RE: Harvard Park Office Park (P17-061)

WALKSacramento has reviewed the rerouting for Harvard Park Office Park (P17-061).

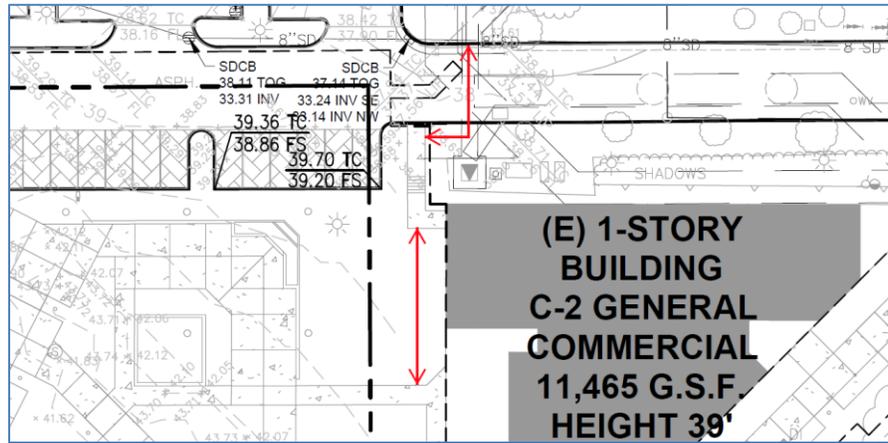
There's no direct path of travel between proposed Building B and the north-south crosswalk at the southwest corner of the existing parking structure. We recommend retaining the existing concrete walk along the west edge of the 11,465 gsf existing building and the existing curb ramp north of the transformer, and filling in the proposed walkways gaps. The path of travel needing completion is indicated with red lines on the diagram below.
